STAFF RECOMMENDATION

706 Fatherland Street

August 18, 2021

Application: New Construction – Outbuilding (Detached Accessory Dwelling Unit)
(Revision to a Previously Approved Plan)

2 B2.0

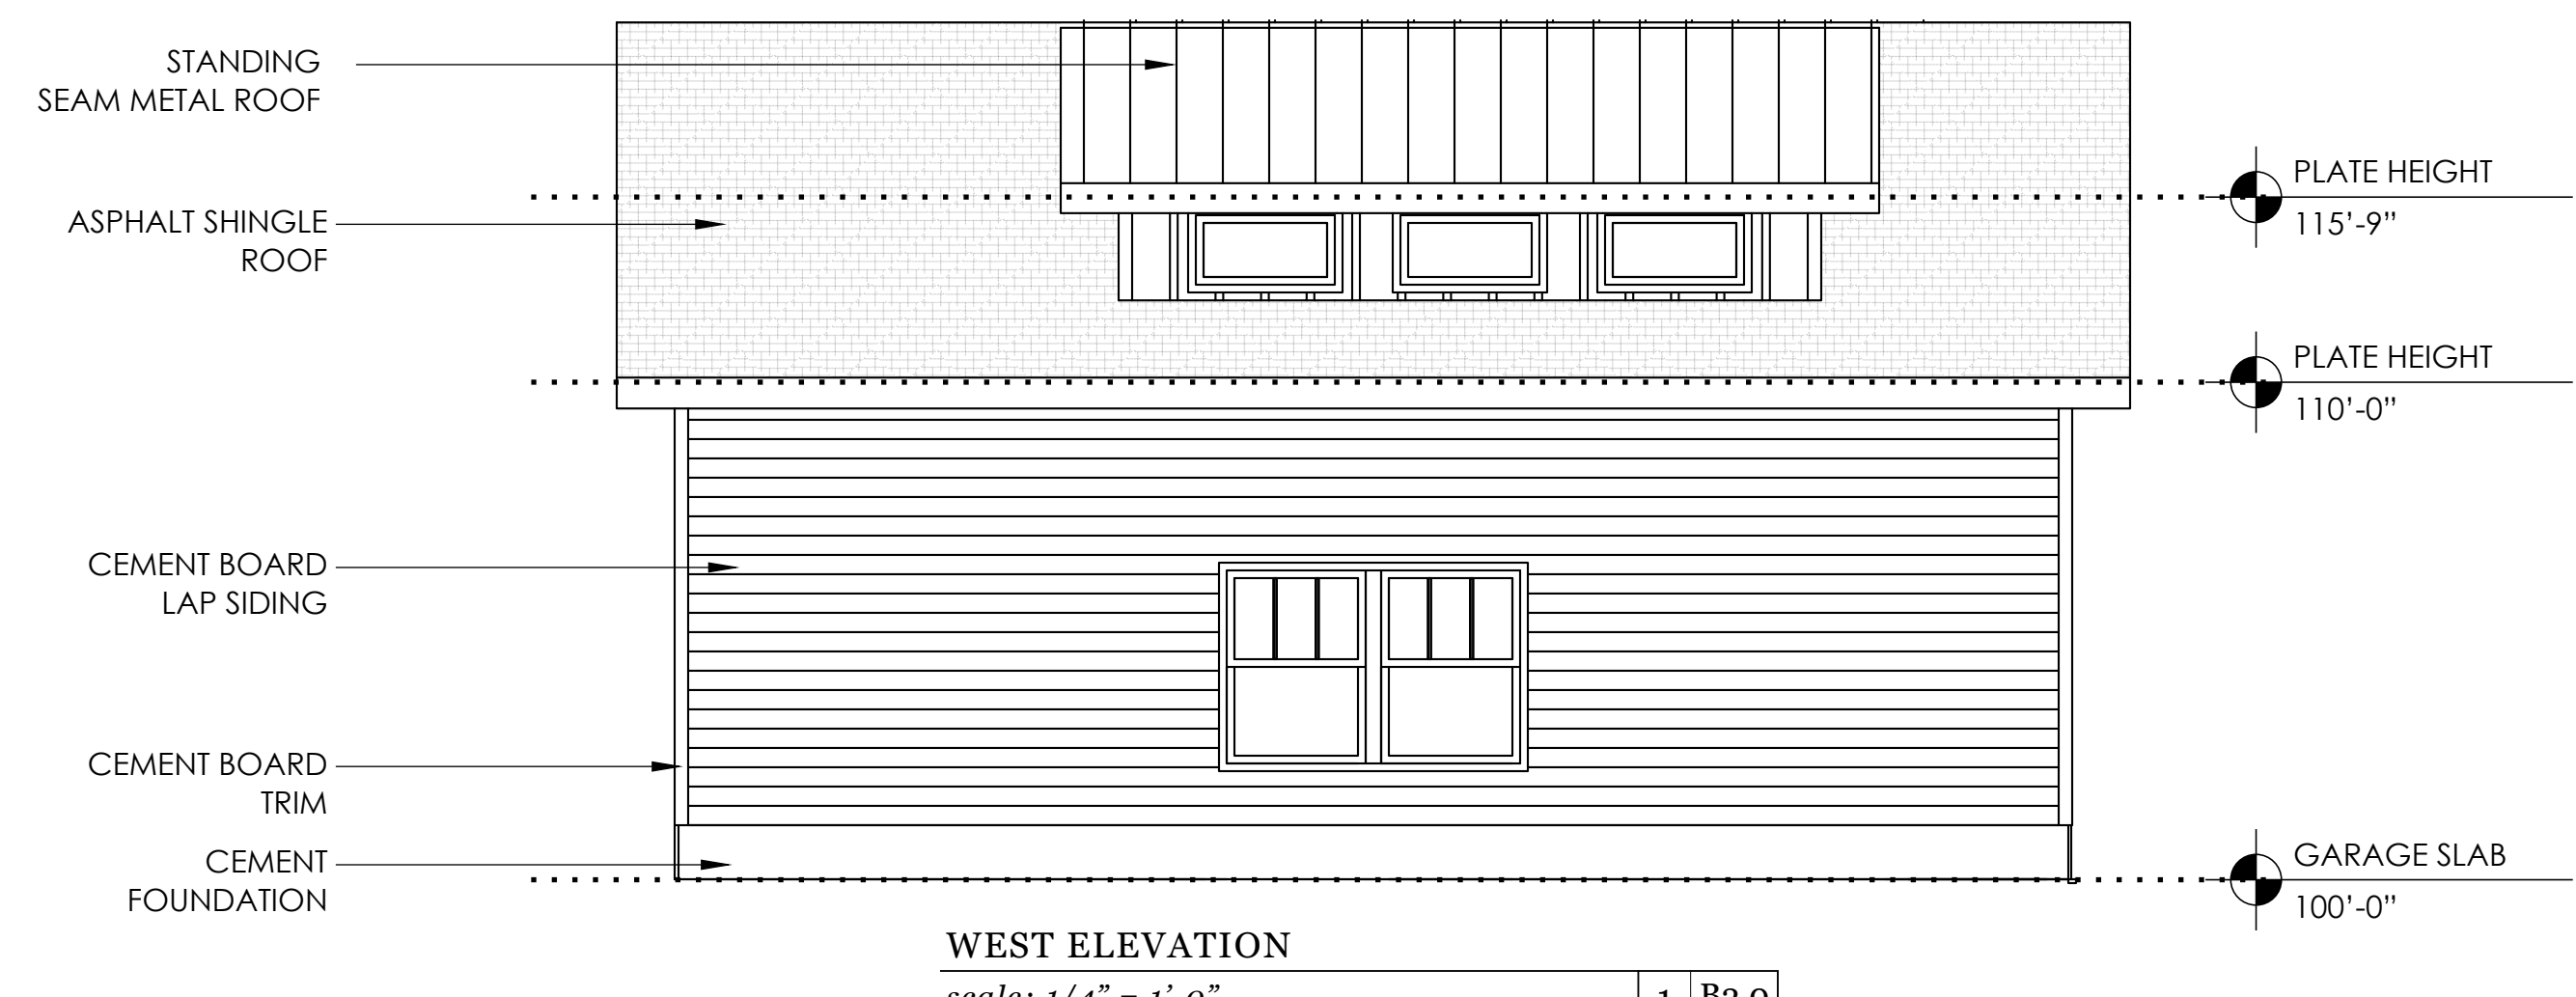
The historic house at 706 Fatherland Street is one-story. The height of the house from finished floor is approximately fifteen feet, six inches (15'-6"), which was field verified by the applicant. The house includes a sixteen-inch (16") foundation, which brings the overall height from grade to sixteen feet, ten inches (16'-10"). The proposed DADU is a one and one-half story structure that is slab on grade with a ridge height of eighteen feet, six inches (18'-6") as measured from grade. While it is often possible to have a one and one-half story outbuilding behind a one-story home, the modest scale of the historic home at 706 Fatherland Street may not make that feasible in this case. Since the lot is larger, it would be possible to increase the footprint to up to one thousand square feet (1000 sq. ft.).

The proposal does not meet Section III.B.2.h.1 of the design guidelines. Since it is not possible to reduce the overall height of the DADU so that it is not taller than the historic house, staff recommends disapproval of the application.

The primary roof form is gabled, which is appropriate. The primary pitch is approximately 5/12 and the dormers have a pitch of 2.5/12, which could be appropriate for dormers if the outbuilding did not exceed the height of the house. Staff finds that the proposal meets Section III.B.2.h.1 of the design guidelines for roof shape.

Recommendation: Staff recommends disapproval of the project, finding that the DADU does not meet Section III.B.2.h.1 of the *Edgefield Historic Zoning District: Handbook and Design Guidelines*.

PROPOSED
DADU

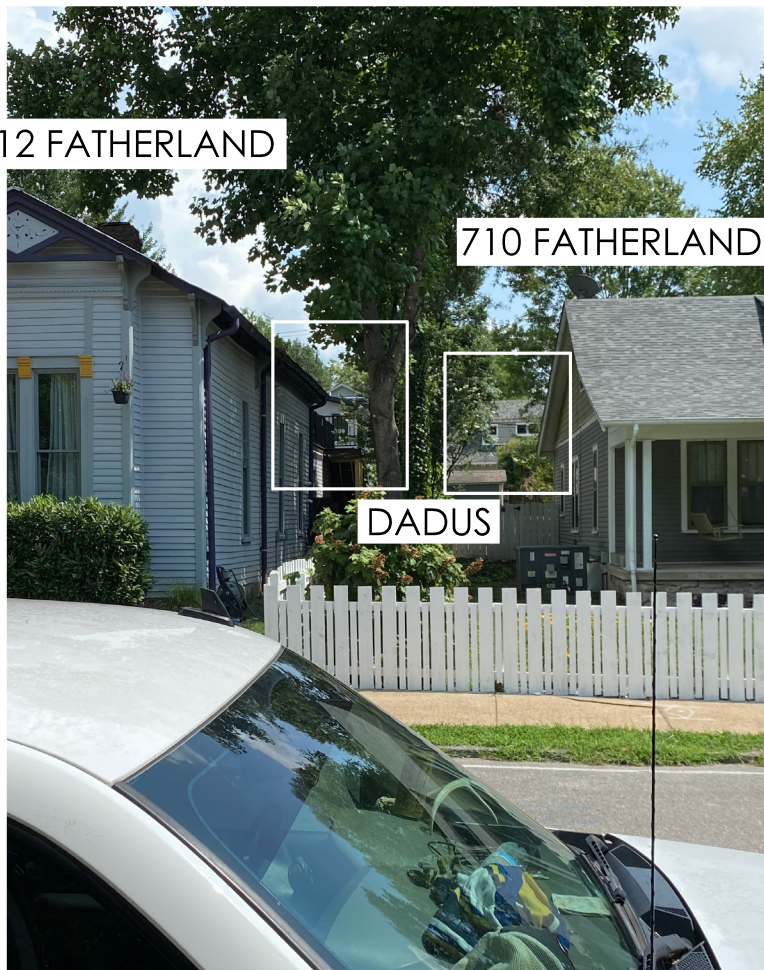
The lot at 706 Fatherland is 210' deep, and the DADU will sit back approximately 90' from the existing house. Due to these dimensions and the existing foliage at the street, the additional 1'8" in height of the DADU in relation to the existing home will not be visible from the street.

Attached are images of the surrounding homes to provide historic context. Several of the homes in this area are significantly higher than 706 Fatherland, including the immediate neighbor of 708 Fatherland. There are also 2 DADUs behind 712 Fatherland and 710 Fatherland, both of which are much taller than our proposed design. With these surrounding structures in mind, we do not believe our design will look out of place.
